Re: Oconee Nuclear Station
Docket Nos. 50-269, -270, -287

In response to the March 31, 1975 letter from Mr. Karl R. Goller, Duke Power Company submits the following proposed Technical Specification changes for the Oconee Nuclear Station.

The proposed revisions apply to Specifications 3.1.3.5, 3.5.2.3, and 3.5.2.5. The revision to Specification 3.1.3.5 incorporates an additional restriction on the regulating control rod positions prior to criticality to assure that the ejected rod worth does not exceed the 1.0% $\Delta k/k$ limit at hot zero power. The revision to Specification 3.5.2.3 deletes the specification on inserted control rod worths but at the same time specifies the manner in which the inserted control rod worths are to be maintained within acceptable limits. Finally, the revision to Specification 3.5.2.5 modifies the rod withdrawal limits for Oconee Units 2 and 3 after the control rod interchange.

UNIT 3
 OCONEE NUCLEAR STATION
 Figure 3.5.2-1C3

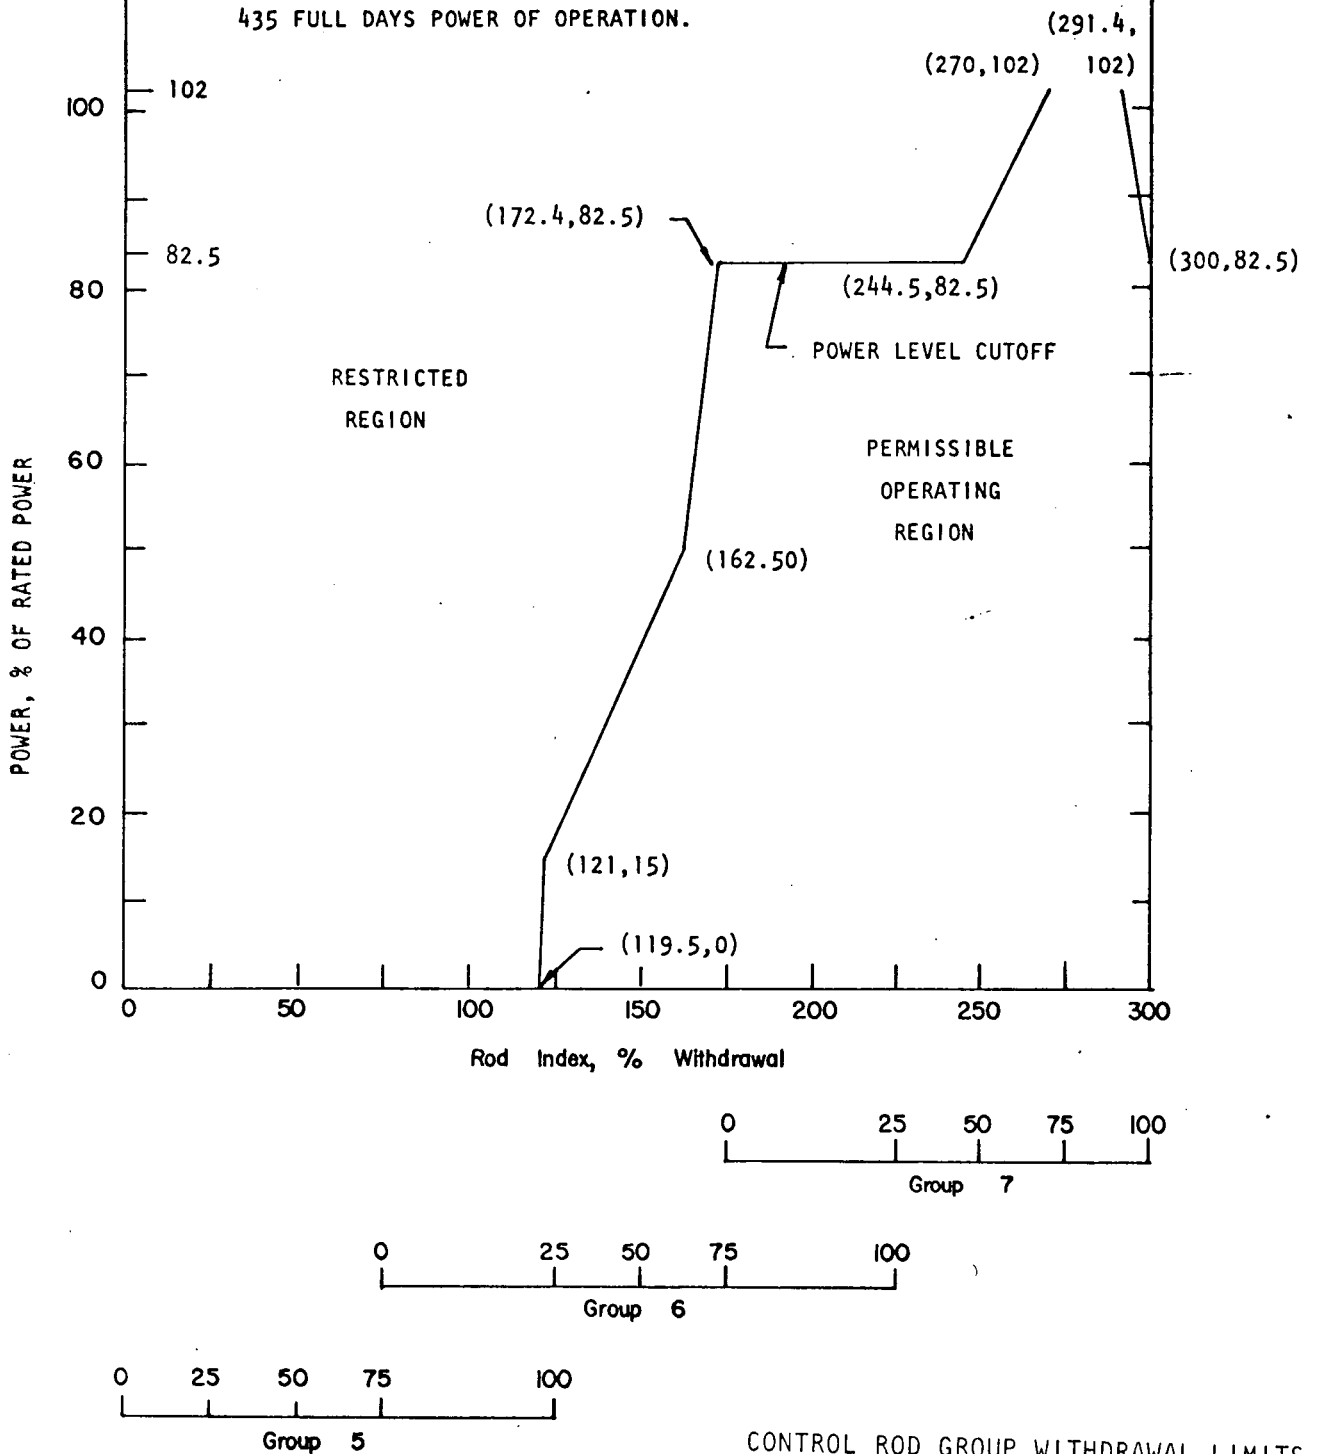
1. ROD INDEX IS THE PERCENTAGE SUM OF THE WITHDRAWAL OF THE OPERATING GROUPS.
2. THE ADDITIONAL RESTRICTIONS ON WITHDRAWAL ARE IN EFFECT AFTER 435 FULL DAYS POWER OF OPERATION.
